**From:** Chris LaRue  
**Sent:** Tuesday, October 1, 2019 10:51 AM  
**To:** Murphy, Chad; Peterson, Mitch  
**Cc:** Chad Schroeder; Wendi Palmer; David Pasic; Fred Starr; Deborah Bachelder  
**Subject:** Rex Ranch Filing No. 3 Preliminary Plat comments  
**Attachments:** Referral Comments.pdf

**Subject:** Rex Ranch Filing 3 Preliminary Plat - Tetra Tech Planning Referral Comments

# REX RANCH FILING NO. 3 PRELIMINARY PLAT

## UTILITY PLAN

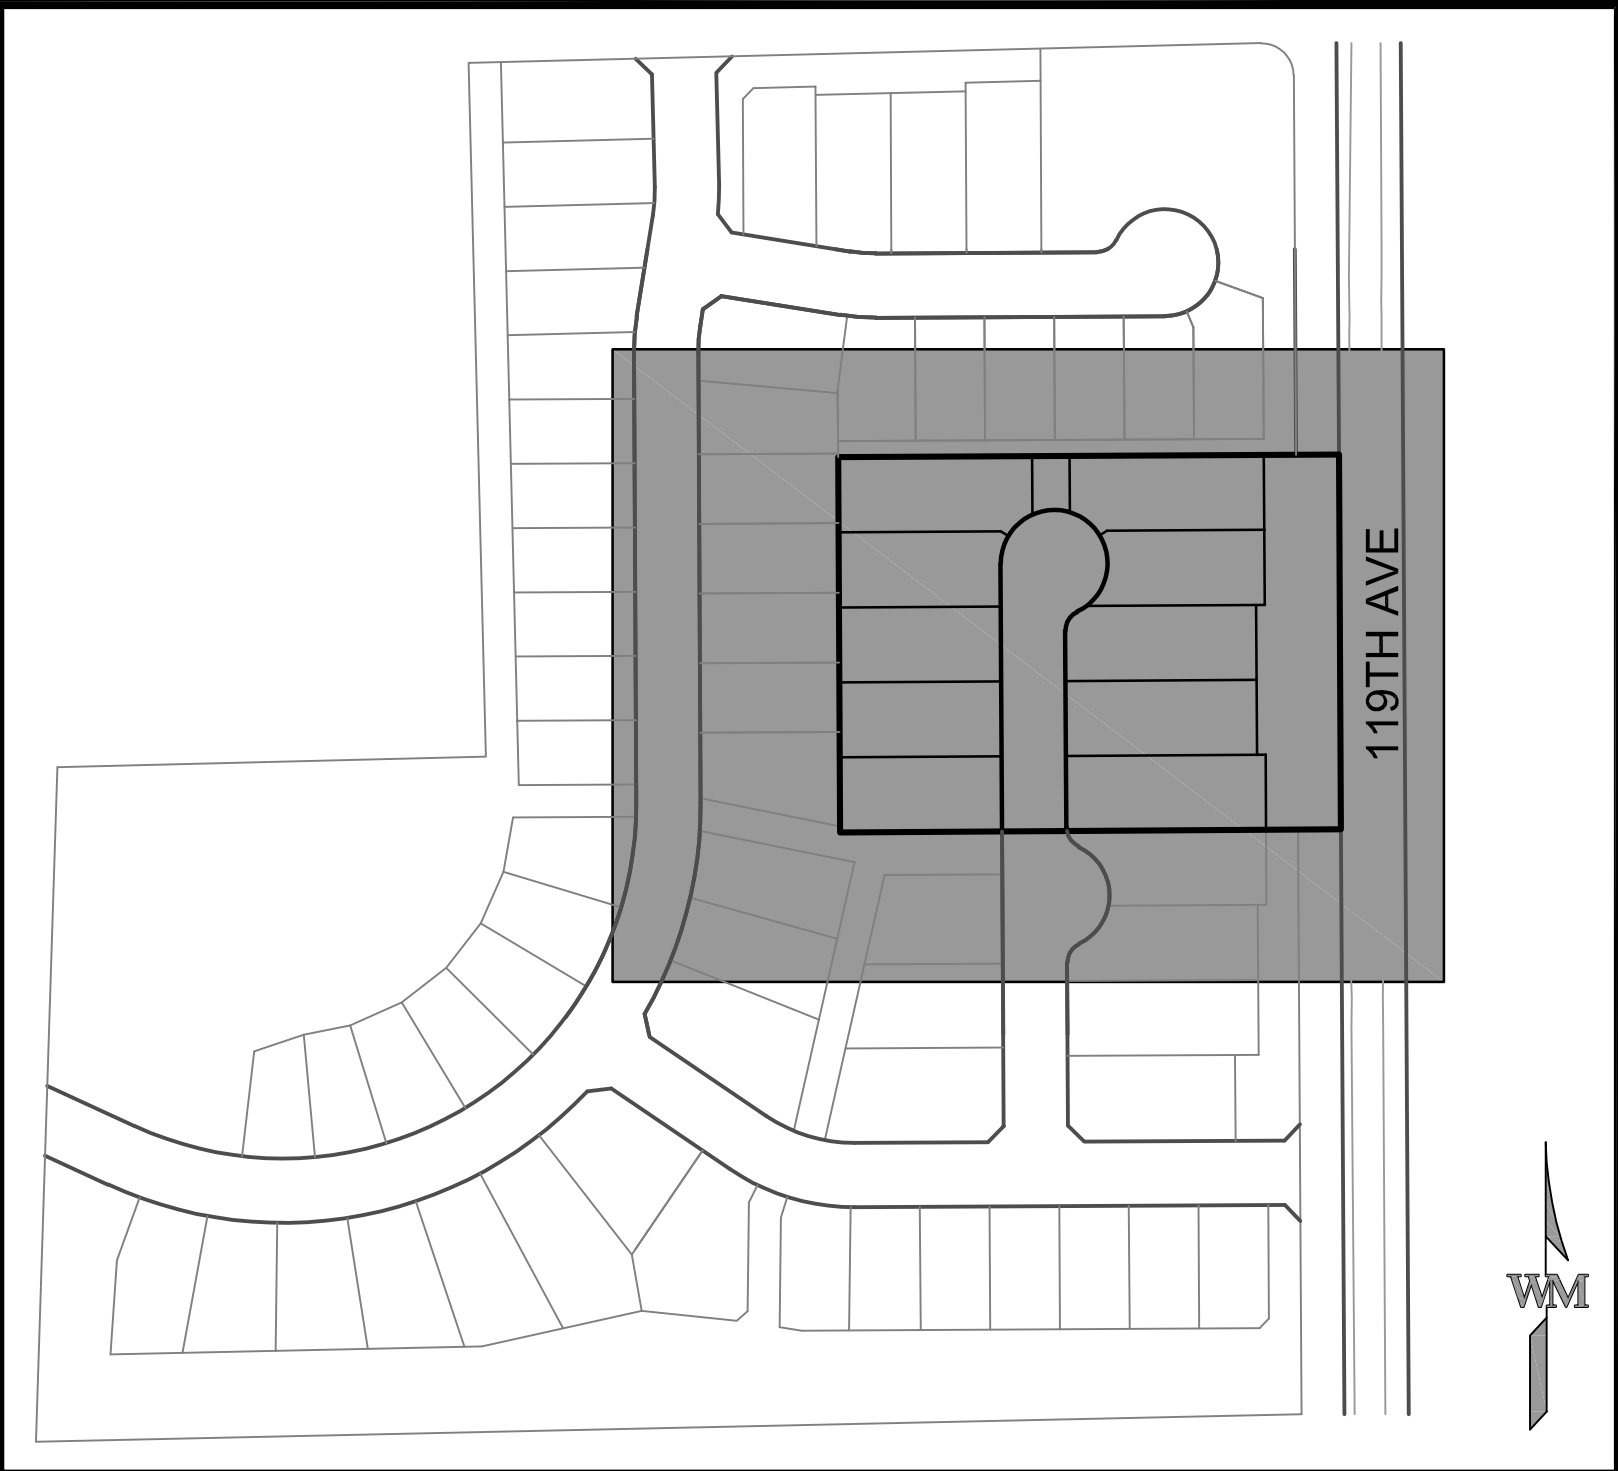
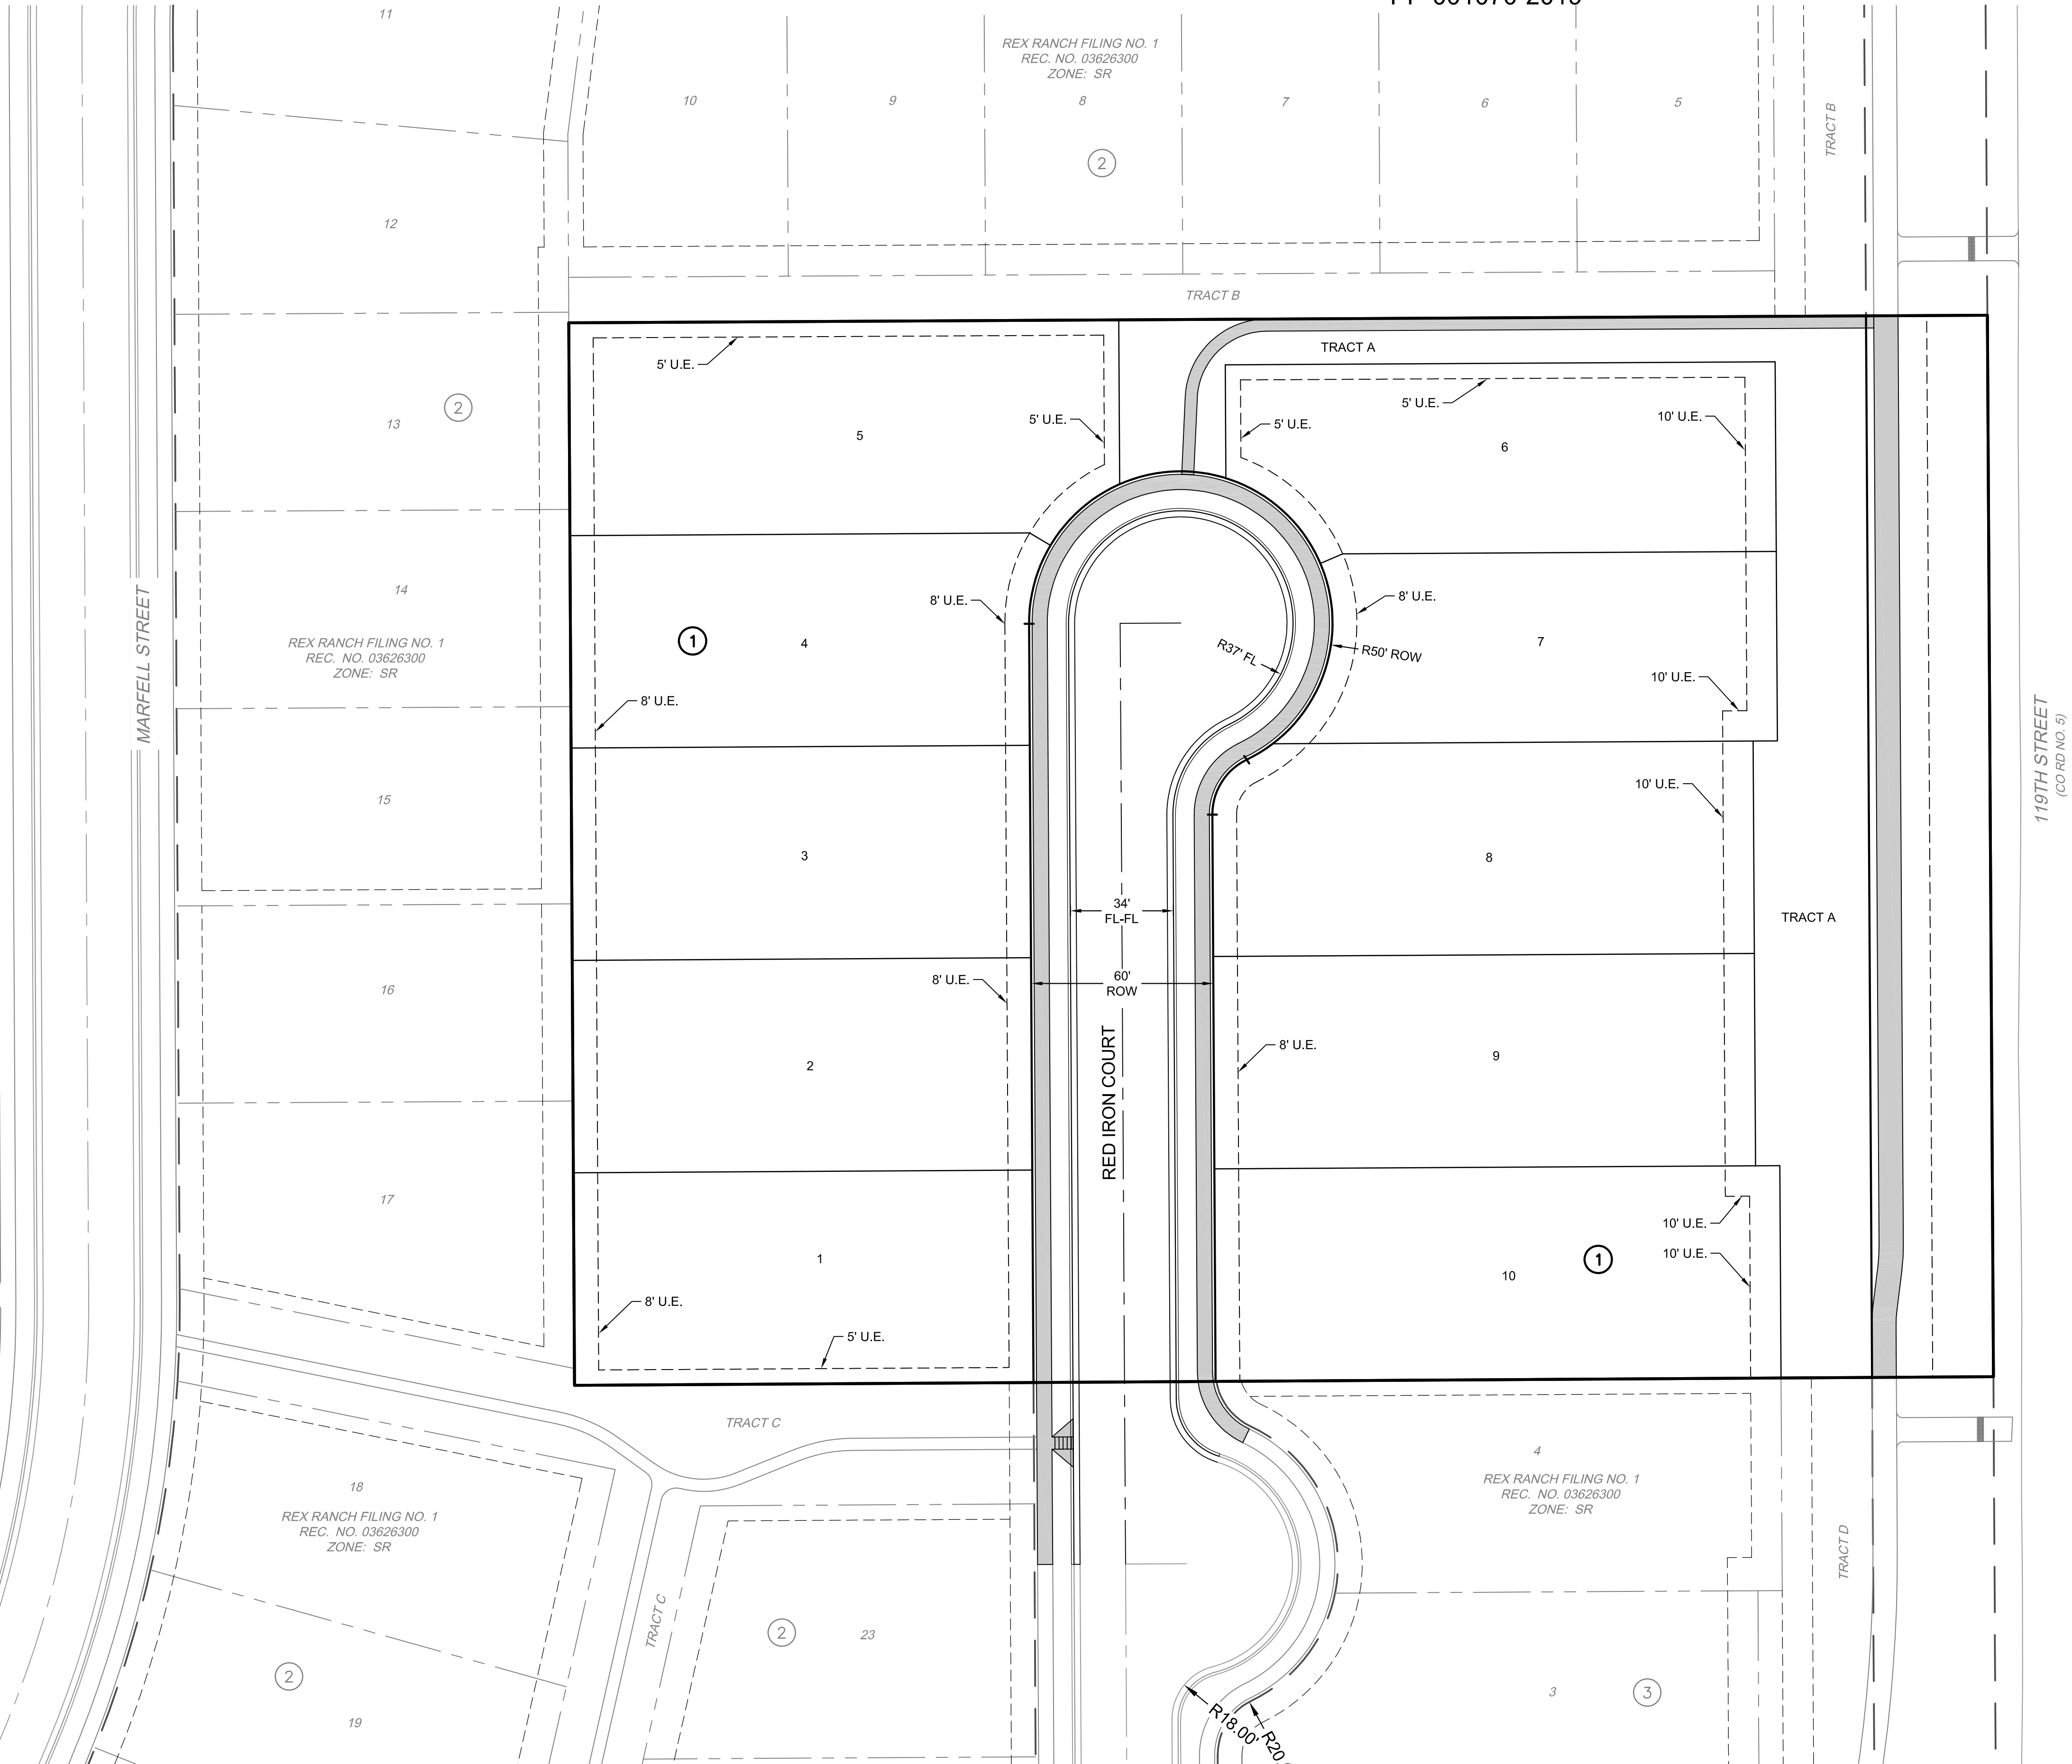
3. Utility Plan: A street light should be placed at the end of the cul-de-sac.
4. Landscape Plans:
  - a. Re-letter the tracts to be consistent with the Plat. There are references to "Tract B" within the Filing No. 3 area. There is no Tract B listed on the plat.
